TO: Advisory Board on Radiation and Worker Health Work Group on TBD-6000  
FROM: Robert Anigstein, Joe Zlotnicki, Dick Olsher, and John Mauro, SC&A  
SUBJECT: Review of NIOSH Report on Response of Film Badges to High-Energy Photons  
DATE: October 28, 2011

### **Review of “Evaluation of the Response of Film Badges to High Energy Photons”**

Figure 1. Film Response with 0.020-inch Tantalum Filter (adapted from Brady and Iverson, 1968) (Lalos 1989, Figure 2-5)

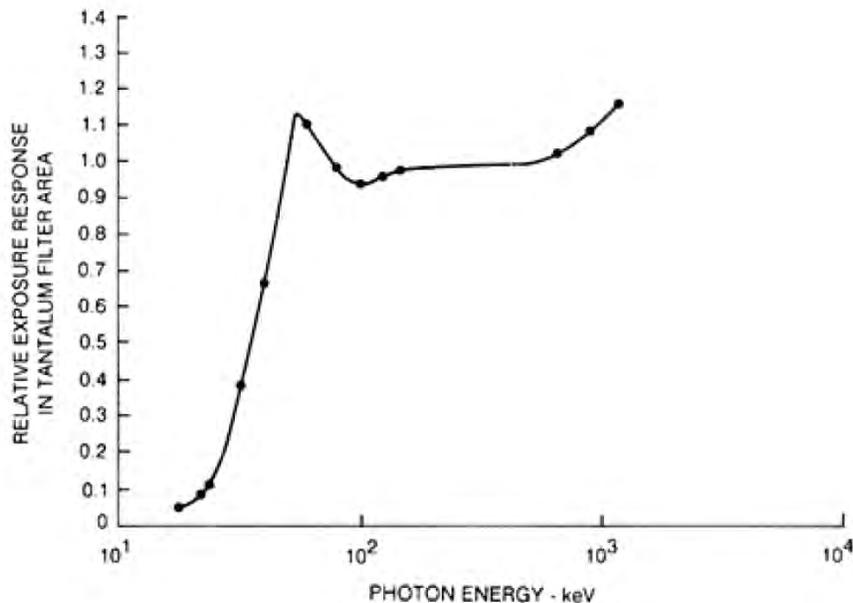
Macievic (2011, Figure 1) illustrated the response of film covered with a tantalum filter to photons with an energy range of approximately 15 keV to 1.2 MeV. Figure 1 in the present memo is reproduced from Lalos 1989, Figure 2-5, the source of Macievic’s Figure 1. As stated in the caption, that figure was adapted from Brady and Iverson 1968; it appeared there as Figure 3. According to these authors: “Figure 3 indicates that, for photon energies from 45 keV

to more than 1 MeV, the tantalum film response for personnel dose is within  $\pm 20$  percent of the cesium gamma air calibration.”

Macievic did not explain what quantity the response of the film is compared to. This question can be resolved by referring to Griffith (2007), who stated:

Macievic (2011) did not indicate the energy of the radiation source used to calibrate the film. According to Brady and Iverson (1968), film badge dosimeters were calibrated by exposing them in air to a  $^{137}\text{Cs}$  source. We independently confirmed the use of this radionuclide as the calibration source by digitizing the data points in Figure 1 and observing that the third point from the right approximately corresponds to an energy of 662 keV (the principal  $\gamma$ -ray emitted following  $^{137}\text{Cs}$  decay) and a relative response of 1.

Macievic (2011) did not identify the type of film used to generate the data in his Figure 1. Brady and Iverson stated that the film was part of the “du Pont Type 556 film packet, including 519 low

range and 834 high range components.” Such information is needed to apply these data to the present issue.

Figure 1 does not include data above 1.2 MeV, although the curve is rising at that point, suggesting a continuing overresponse at higher energies. According to Lalos (1989): “Exposure to photons with quantum energies above 2 MeV may result in a situation in which the density under the filters is greater than the density in the open window area, with the greatest density occurring under the high-Z filter.” This indicates that the film would overrespond to high-energy photons. The low sensitivity of the tantalum-covered portion of the film to low-energy photons shown in Figure 1 is due to the shielding by the tantalum filter. These photons are also detected by the plastic-covered portion of the film, and a processing algorithm uses the readings from both portions of the film to derive the dose to the film-badge wearer. In fact, a major motivation for the original use of metal filters was to account for the overresponse of the unshielded emulsion to low-energy photons, a primary source of radiation exposure of individuals employed in medical radiography.

Figure 3. Exposure Rate vs. Photon Energy in Control Room (location #1 in Figure 2)

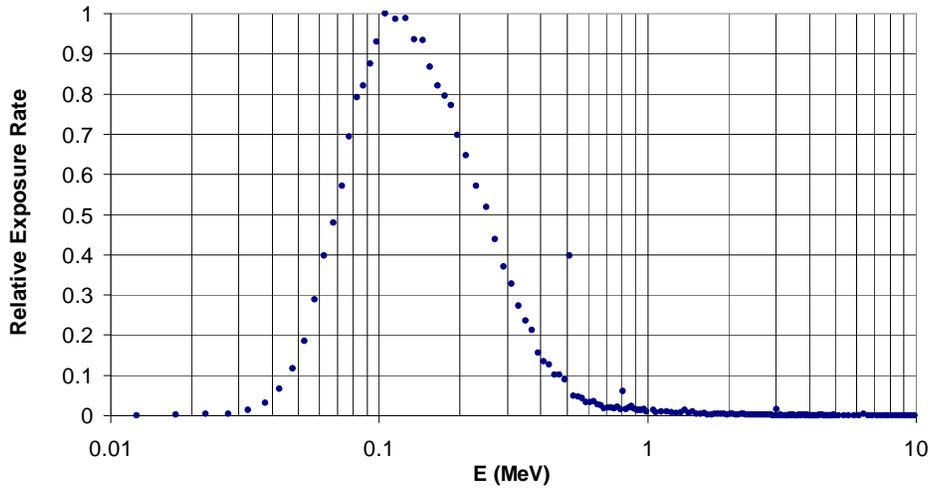
Figure 3 shows the exposure-rate spectrum (i.e., exposure rate vs. photon energy) in the control room, near the door to the shooting room. Our analysis shows that 99% of the exposure rate is from photons  $E < 3.6$  MeV, while 90% of the spectrum lies between 45 and 540 keV. The exposures in this energy range fall within the  $\pm 20\%$  relative sensitivity range of the film described by Brady and Iverson (1968), as quoted earlier in this memo.

Figure 4. Cumulative Exposure Rate vs. Photon Energy in Restroom (location #6 in Figure 2)

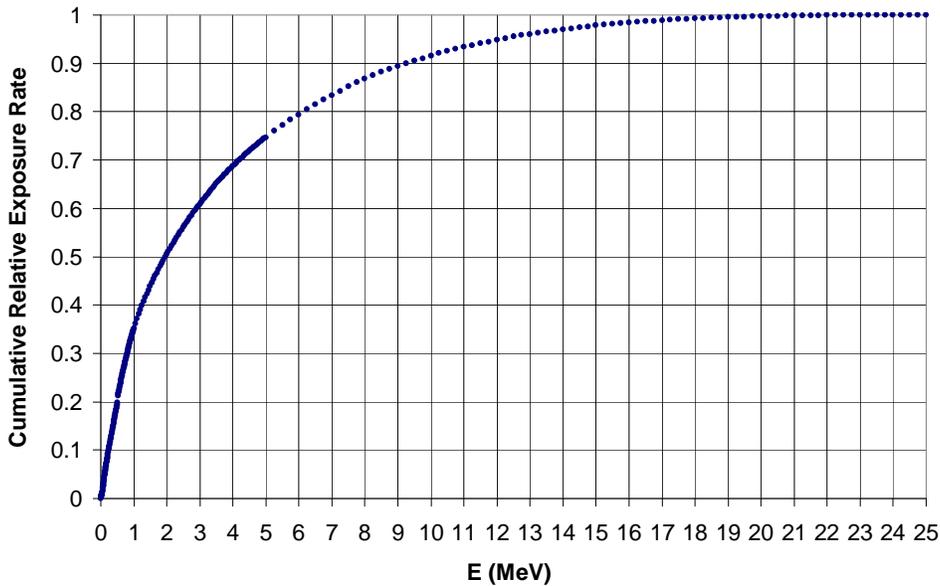
Figure 4 shows the cumulative exposure-rate spectrum in the restroom. As shown in this figure, 50% of the exposure rate is due to photons  $E < 2$  MeV, while 90% is below 9.25 MeV. This analysis was based on the drawings of the betatron building in reports available at the time of the original SC&A (2008) analysis, which indicated only a thin wall along the rail tunnel on the northwest side of the building. A drawing that accompanied the report of a radiological survey

of an 80-Ci  $^{60}\text{Co}$  source in the New Betatron Building (NRC 2009, p. 16) showed that this wall was 2 ft thick, which would have significantly attenuated the radiation field in the restroom. The additional scattering caused by the thicker wall would soften the spectrum, bringing it closer to that in the control room. However, the spectrum derived in the present analysis can be used to represent a limiting case, encompassing other lightly-shielded locations.
